UNITED STATES
NUCLEAR REGULATORY COMMISSION
WASHINGTON, D. C. 20555

September 19, 1979

SUBJECT: MEETING ON PHILIPPINES NUCLEAR POWER PLANT (PNPP),
BETHESDA, SEPTEMBER 18, 1979

POSITION PAPER NO. 2 OF NSSEEP

Figure 1 (NSSEEP)

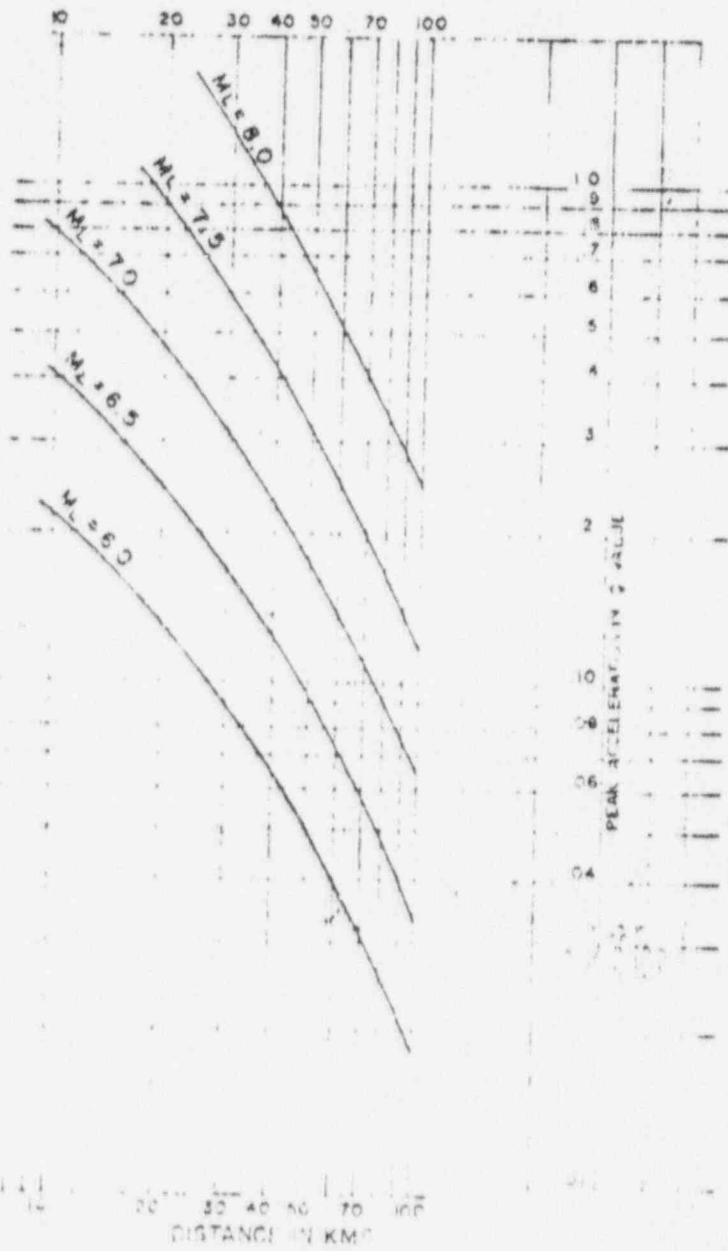
and submit that these curves are more reliable and applicable.
Figure 1 NSSEEP.

Figure 2 (NSSEEP)

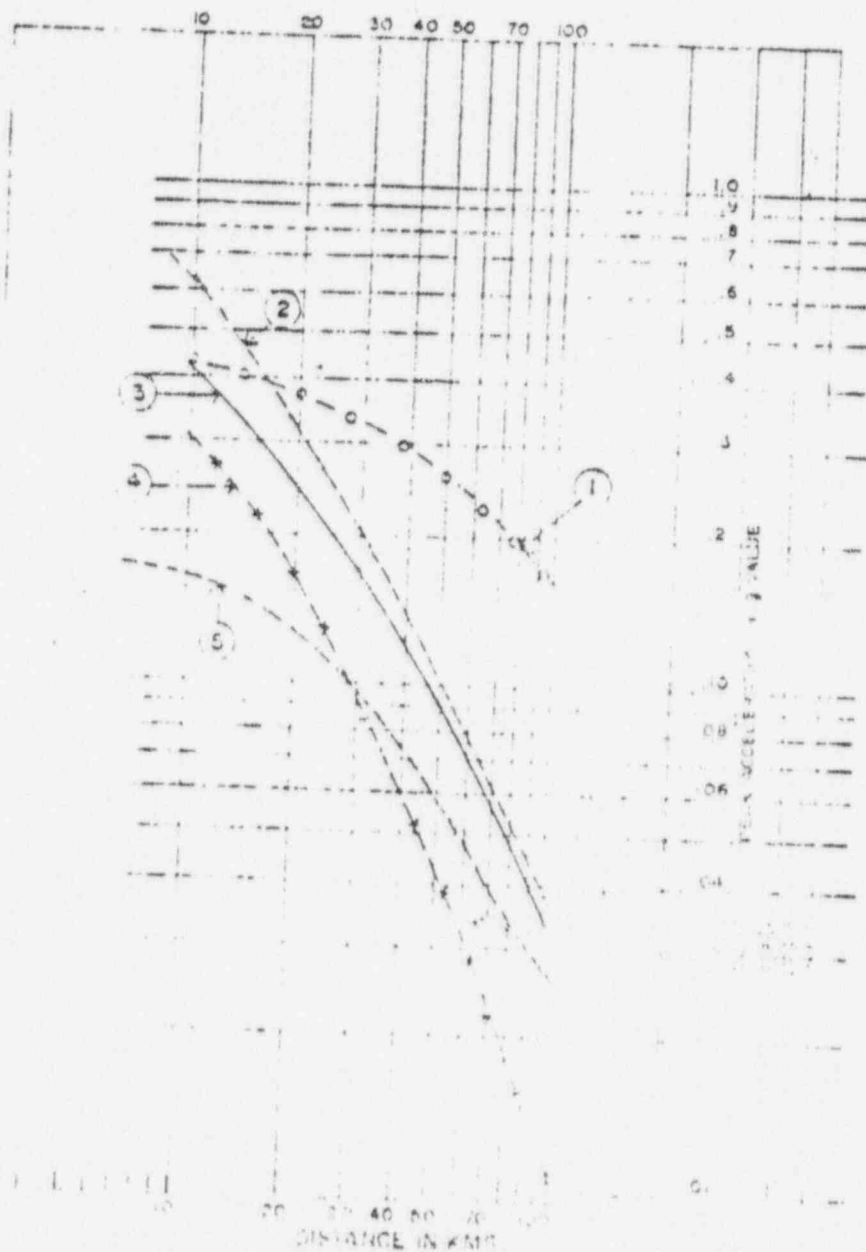
Position No. 5 (e) - We submit Figure 2 NSSEEP containing a comparison of attenuation curves on magnitude 6.5. We submit that if the Philippine attenuation curves are not used, the attenuation curves derived from California and Japanese earthquakes are more applicable than the ones used by Ebasco.

Figure 3 (NSSEEP)

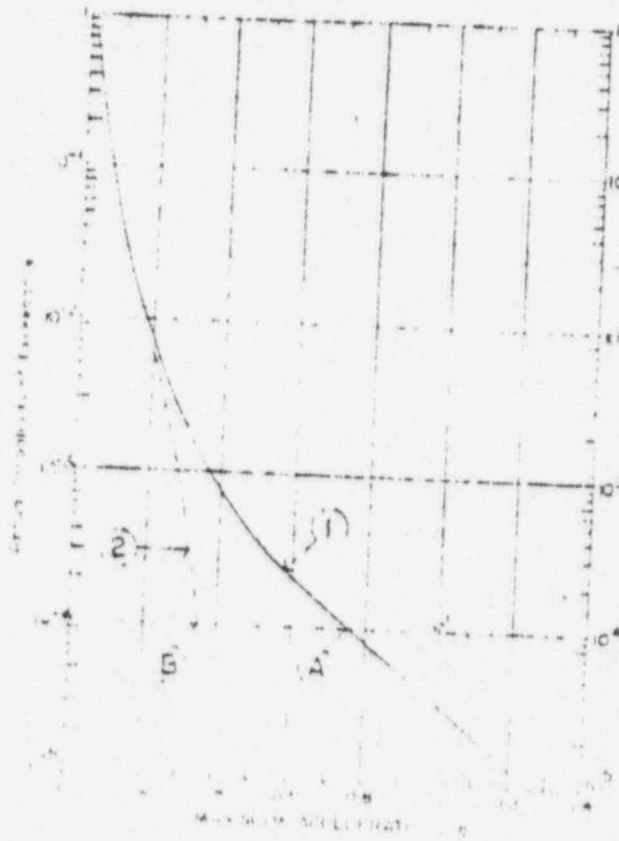
Position No. 5 (f) - We submit Figure 3 NSSEEP with Ang-Newmark $\ln A$ and the Ebasco curve (worst case) and suggest that the maximum

ground acceleration to be considered on the U.S. Geological Survey return period of 10,000 years should be 0.75 g and not 0.35 g, based on Ebasco seismic risk analysis. We believe a design of the Nuclear Plant based on 0.35 g would be unsafe.

FIGURE 4 (NSSLEP)

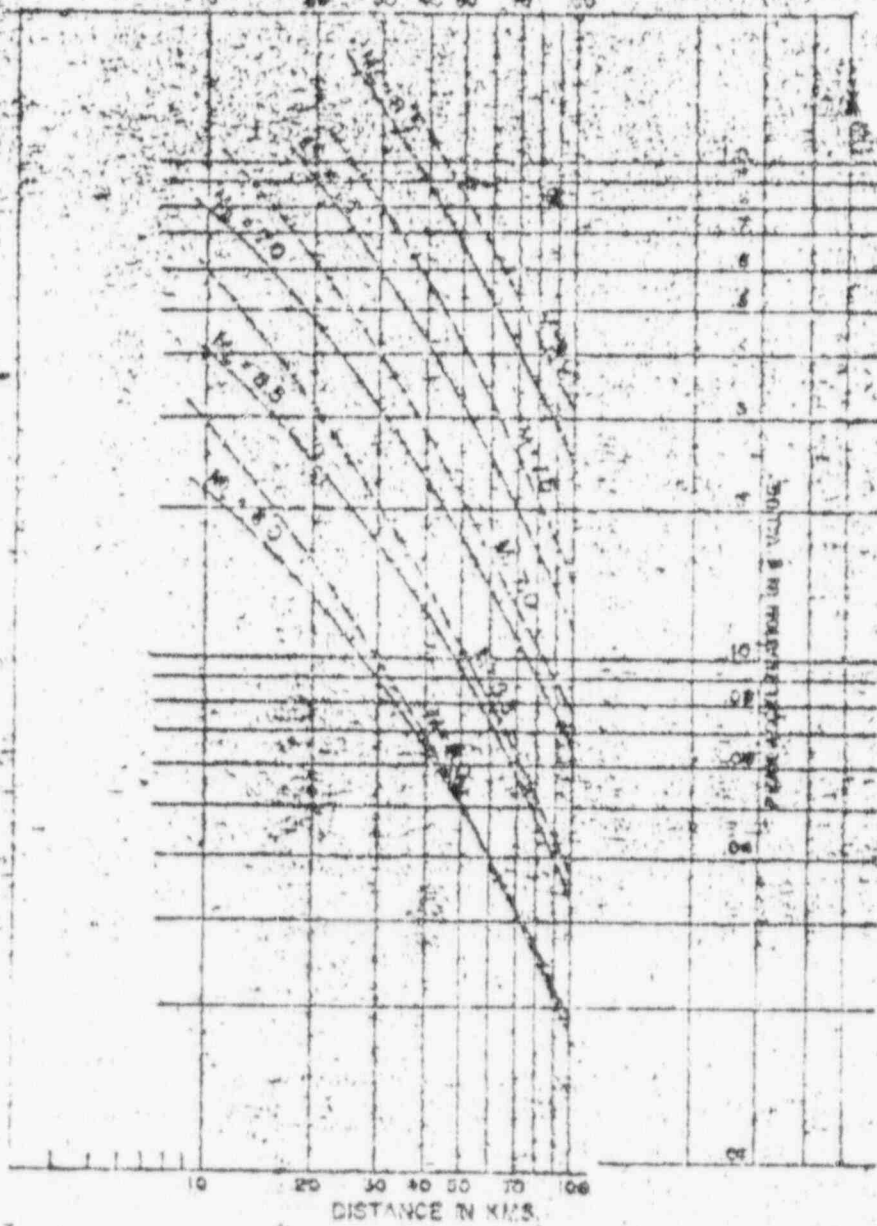
There is presented herewith Figure 4 (NSSSEP) showing a comparison of Attenuation curves, Kanai (California and Japanese earthquakes) and Manila Observatory (Philippine earthquakes).

Figure 5 (INSSEEP)

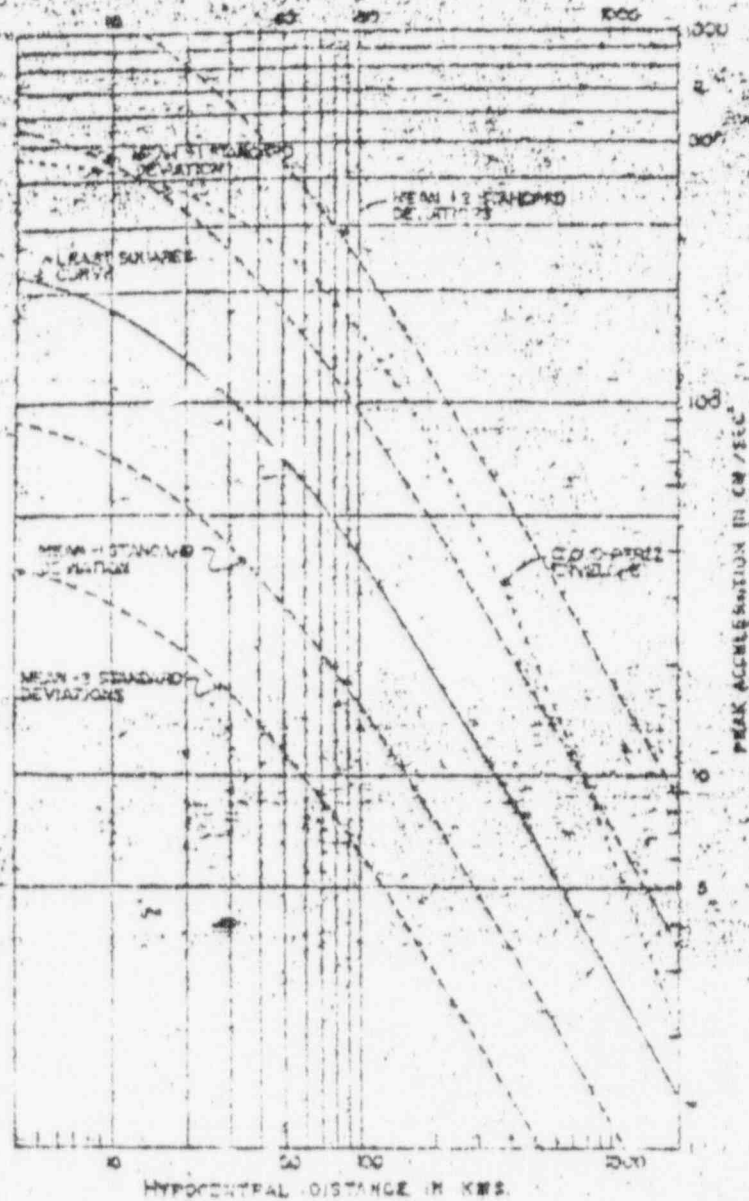
There is presented herewith Neville C. Donovan curves taken from "Earthquake Hazards for Buildings" from previously cited "Building Practices for Disaster Mitigation" p. 39, Figure 5 (NSSEEP).

FIGURE 1
 OVERLAY MAP
 FRAME NO. 118-01502

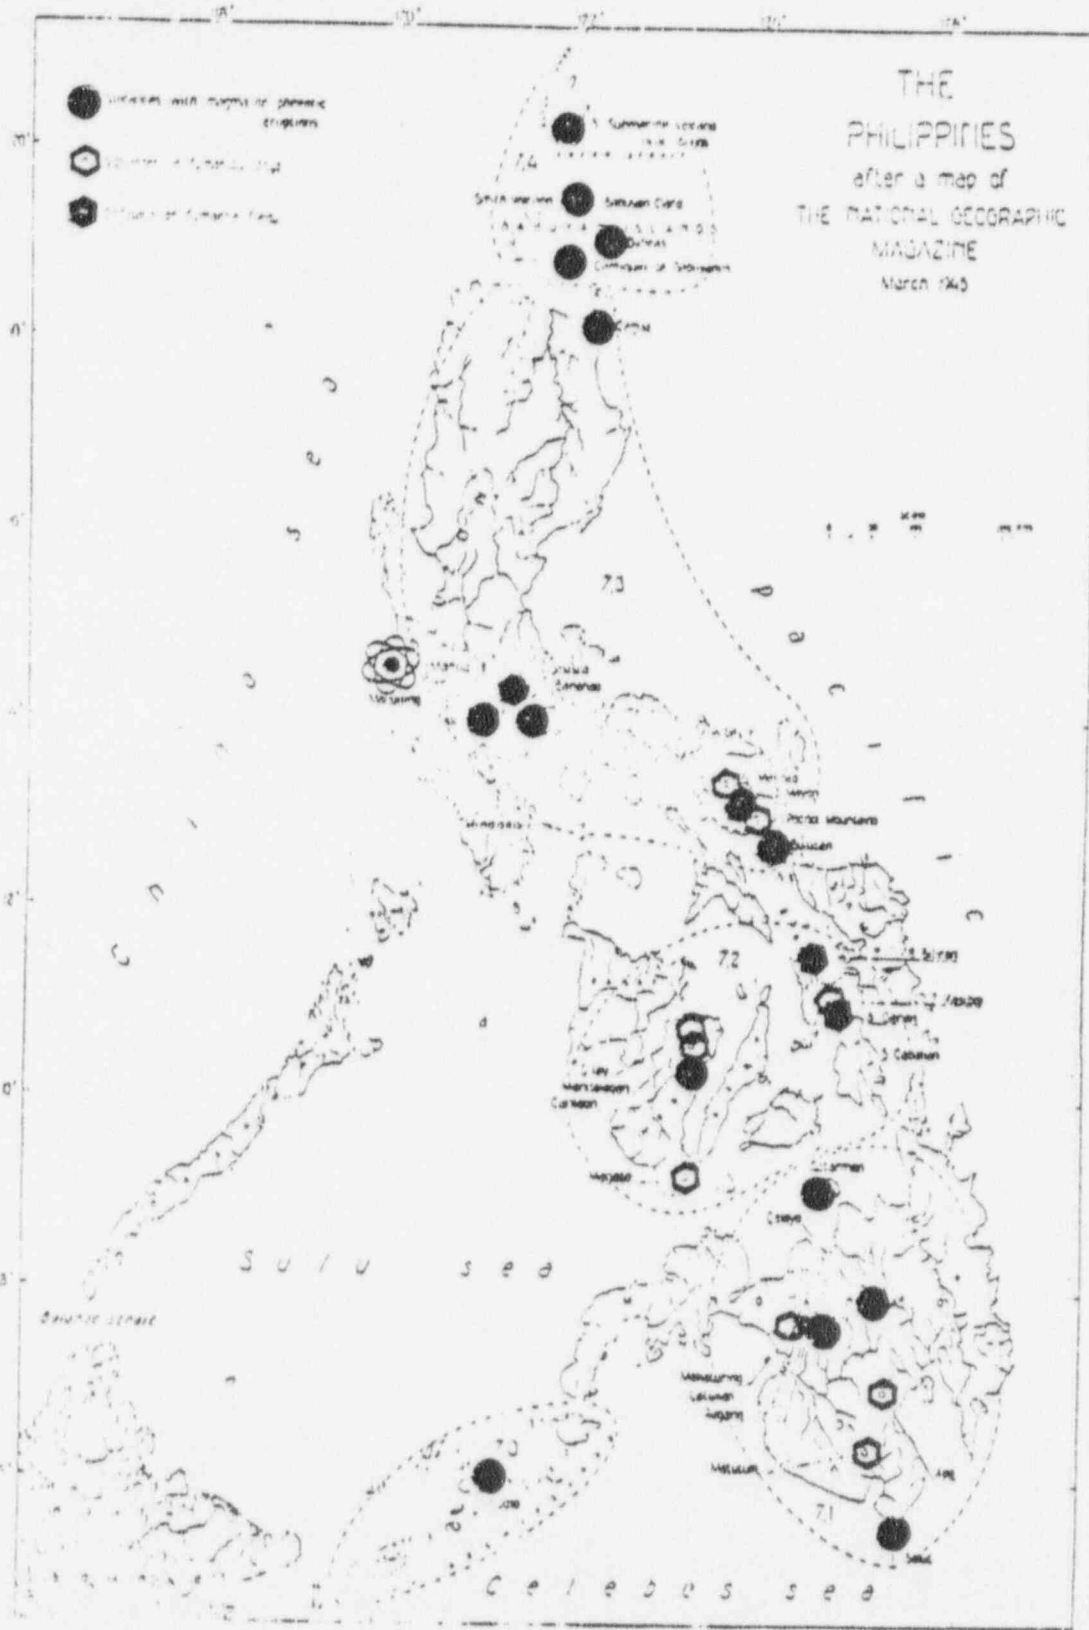
1. In the satellite photograph (Landsat Imagery, scale 1:1,000,000) a conspicuous northwest (NW) trending lineament about 4 km northeast of the Nuclear Power Plant Site, and an inconspicuous northeast (NE) trending system of lineaments passing near the vicinity of the plant site were interpreted (see Fig. 1).
